From: Proximity <proximity@cn.ca>
Sent: Friday, September 21, 2018 9:29 AM
To: Hedy Higgins
Subject: Brandon, 660 – 7th Street & 725 Van Horne Avenue (File #Z-06-18-B & V-16-18-B)
Attachments: Submission - 16.07.22.pdf; CN Rail - PML - Sensitive.pdf

PROJECT NAME:
660 7th Street & 725 Van Horne Ave
SITE PLAN

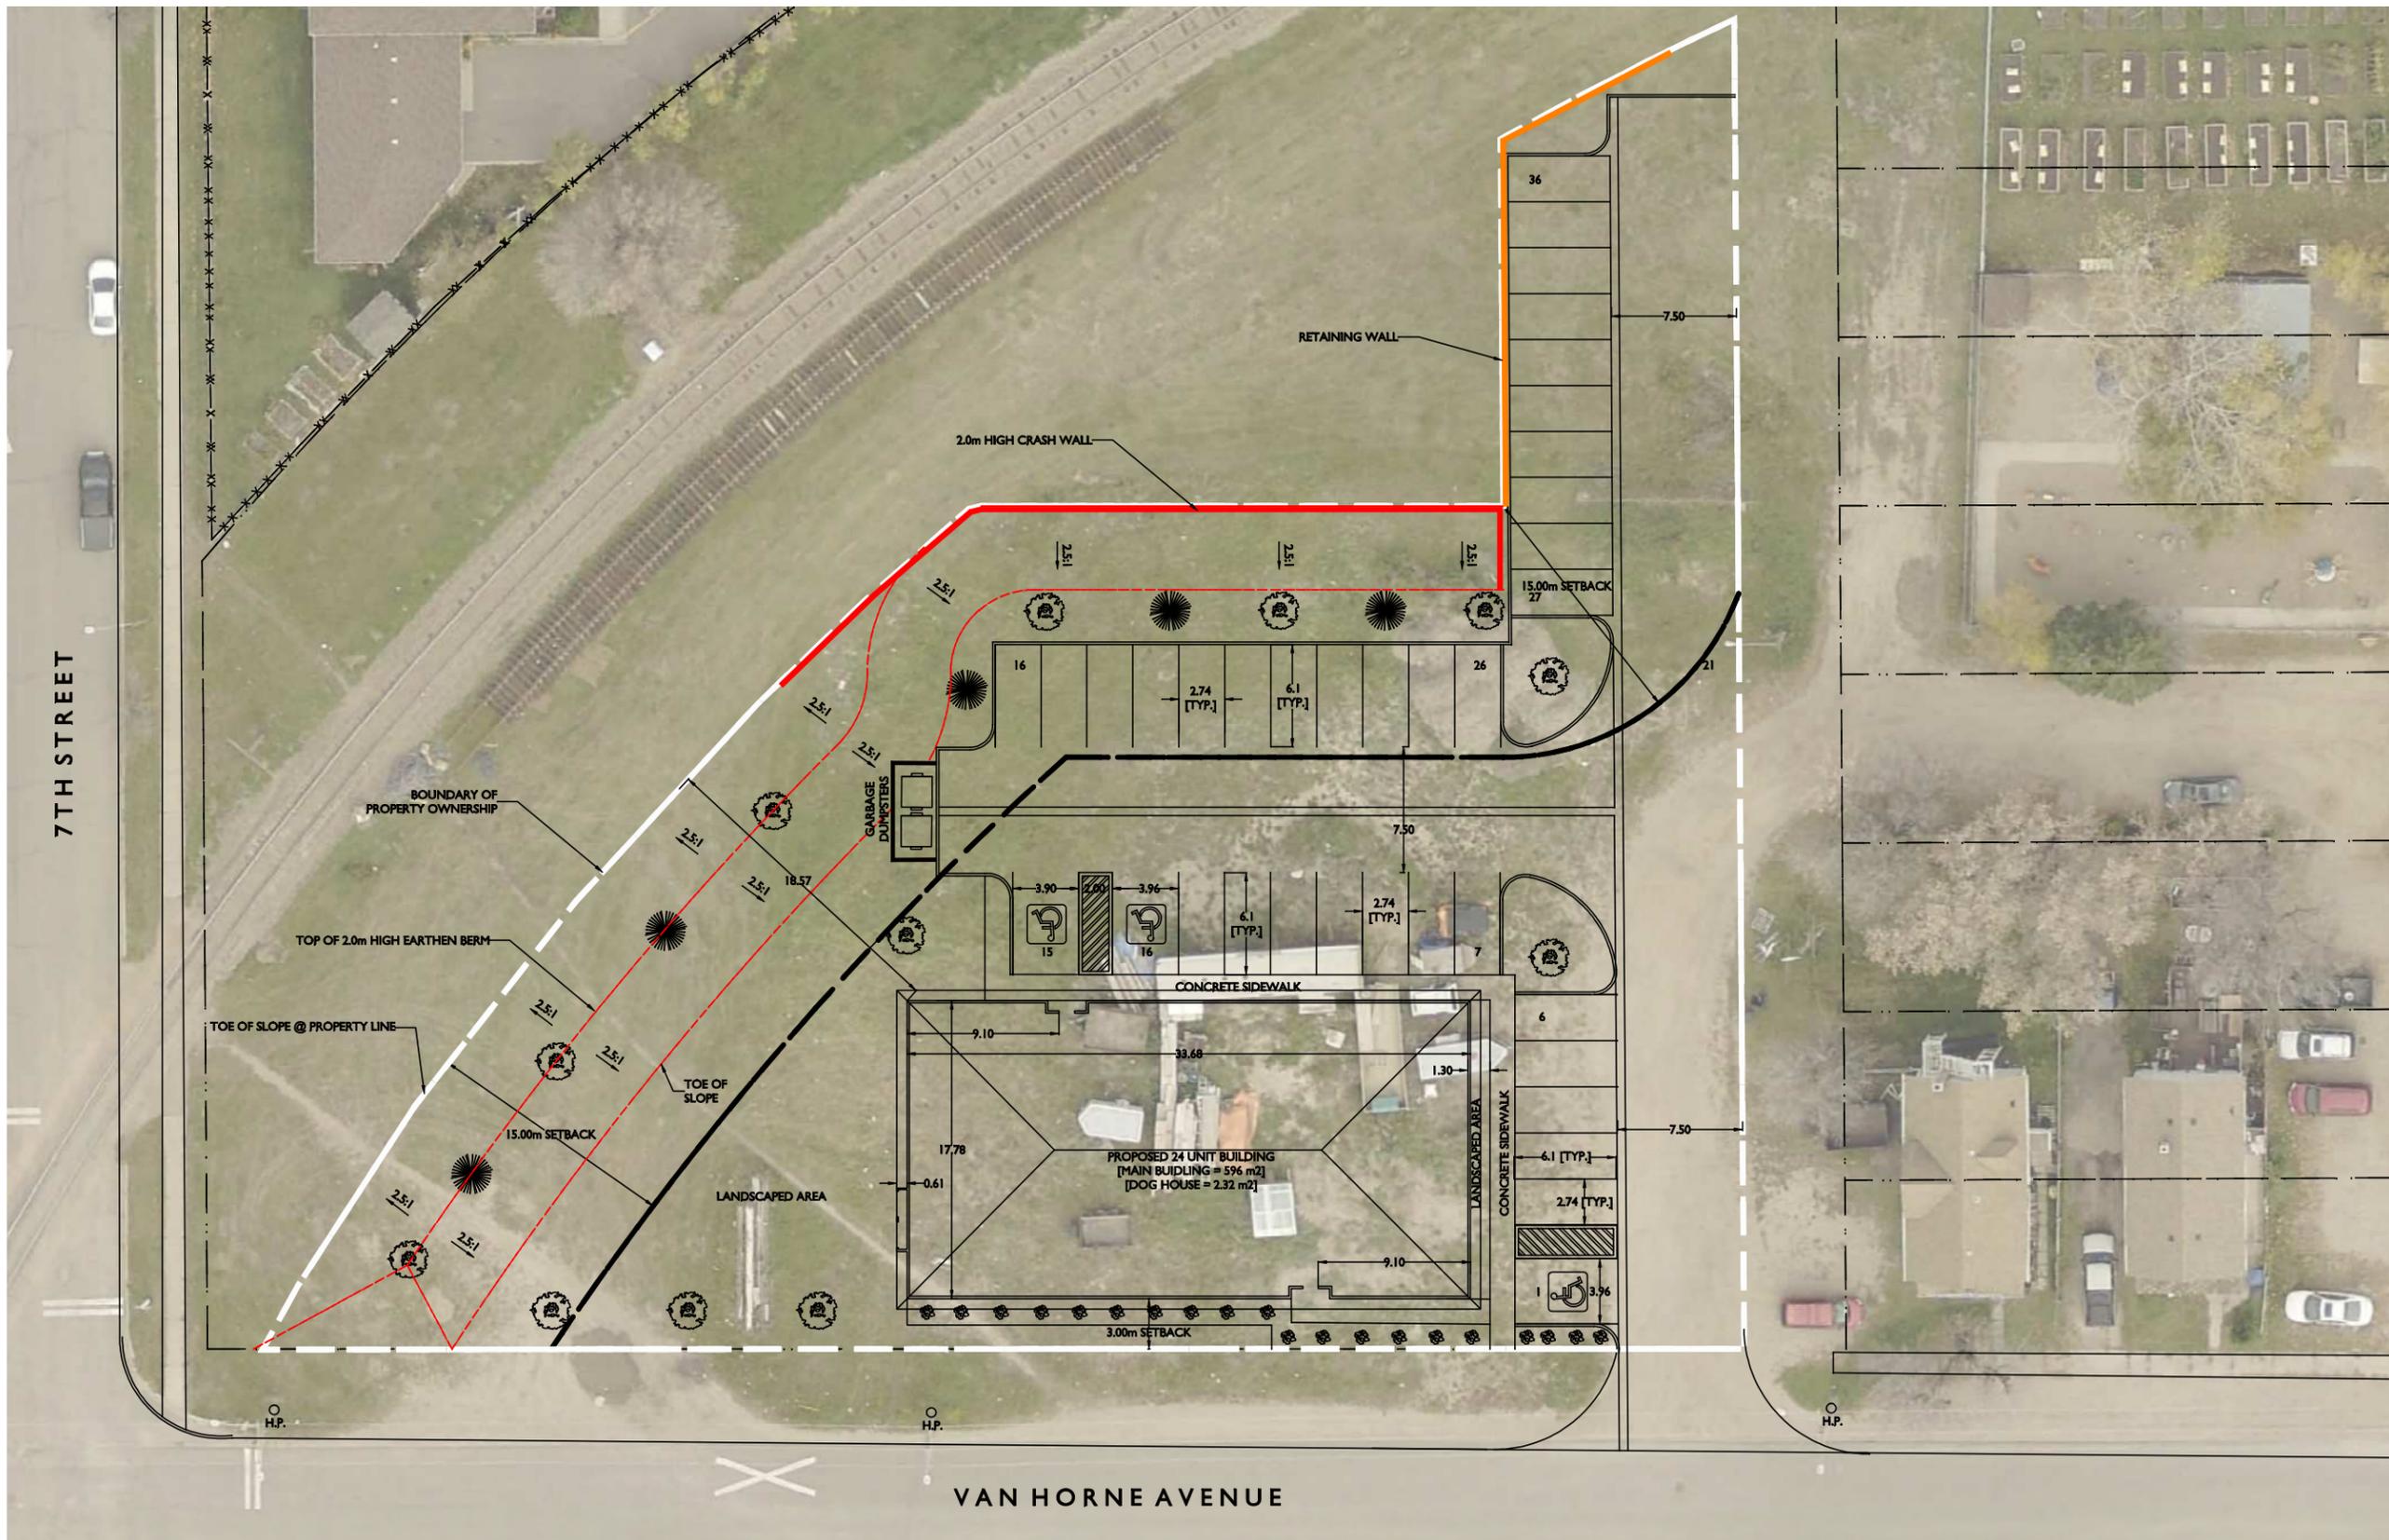
CN has previously reviewed and commented on a previous proposal for a 24 unit development (attached) pertaining to the subject site. The proposal included a crash wall along the parameter of the property where the railway corridor curves, as well as a retaining wall and an earth berm along the remaining portion of the property. The current proposal shows a lower berm height of 2.0 metres along the parameter of the property, elimination of the crash wall and a potential development density increase to 32 units. While a berm typically serves as a safety barrier for residential or otherwise sensitive uses, crash walls are often used for urban infill projects with a higher density, as they require a much smaller footprint. Given the project's density, sensitivity, location and site conditions, the proponent may wish to consider implementing a crash wall instead of an earth berm. CN is prepared to consider a reduction in the minimum required setback of 30 metres from the railway property line, provided that it can be clearly demonstrated that any adverse impacts created by such a reduction in setback will be adequately addressed, as to not adversely affect safety and liveability for future occupants.
